PREPARED J. BRADLEY	DART AERO ACCESSORIES INC VICTORIA INTERNATIONAL AIRPORT, CANADA
APPROVED <i>[Signature]</i>	DEO 902 1 REV.: A SHEET 1 OF 22
DATE 94.11.17	Kwik-Float Ammendments

ENGINEERING ORDER

FOR OPTIONAL FORWARD BELLY LOCATION OF GAS CYLINDERS

SUBJECT: **ALTERATIONS TO KWIK FLOAT KITS DUE TO COMPLIANCE WITH BELL HELICOPTER TEXTRON, ALERT SERVICE BULLETIN 206-94-78.**

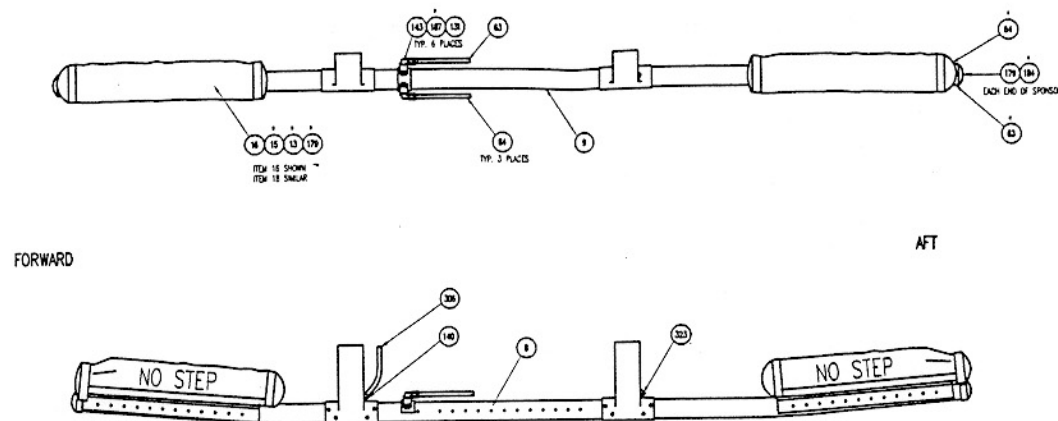
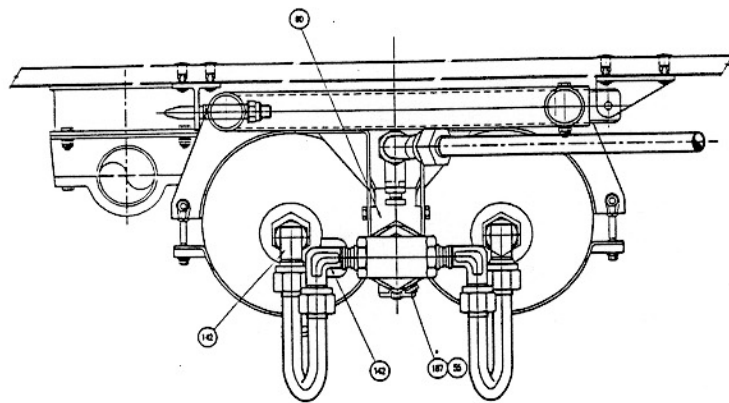
DRAWING CHANGES			
REV.	ENG. CHANGE NOTE	DATE	REVISION DESCRIPTION / REASON
1	Original Issue	11-03-84	ORIGINAL ISSUE
2	BHA/DRA/469-03-02	11-03-84	UPDATE
3	BHA/DRA/469-03-03	11-03-84	UPDATE OF INFORMATION

DRAWN	J MOSCATO	Client	HELITECH PTY. LTD.
DATE	15/11/94	Title	CROSS TUBE BRACKETS
SCALE	Not to Scale	Weight	
		Drawing Number	358-94-02A
		REV

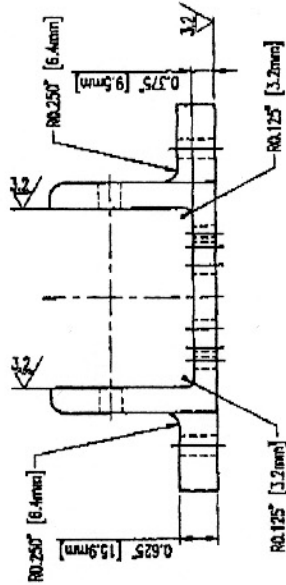
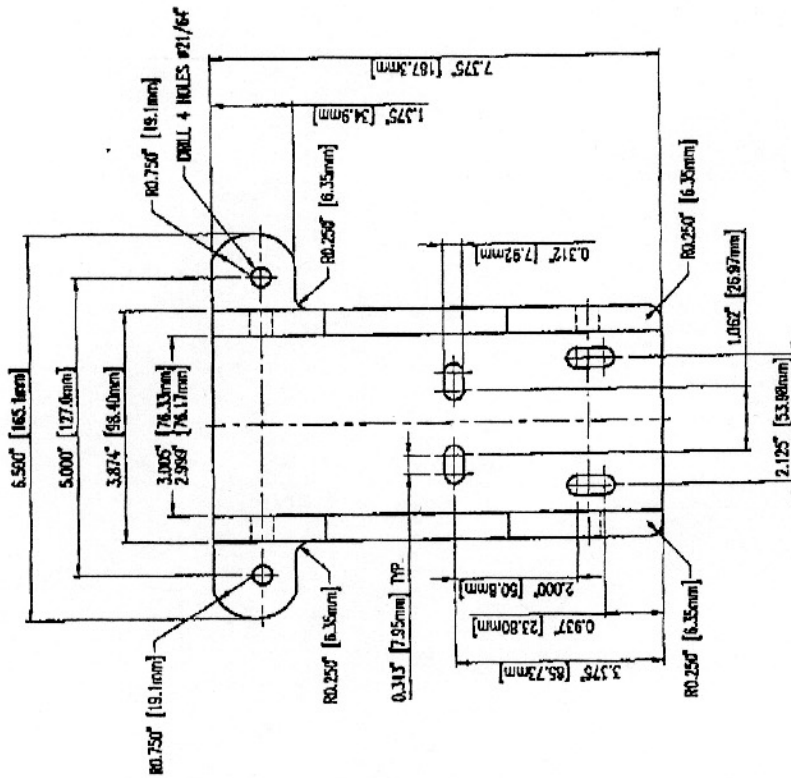
5. Modify Cross Tube Supports I.A.W. attached Drawing 358-94-02A by machining lower attachment bolt holes. The machining process will elongate the holes to 0.438 inches or 11.125 mm.

Add suffix "A" to support part number using an electric pencil and then restore the paint finish.

358-013-001

358-013-001A
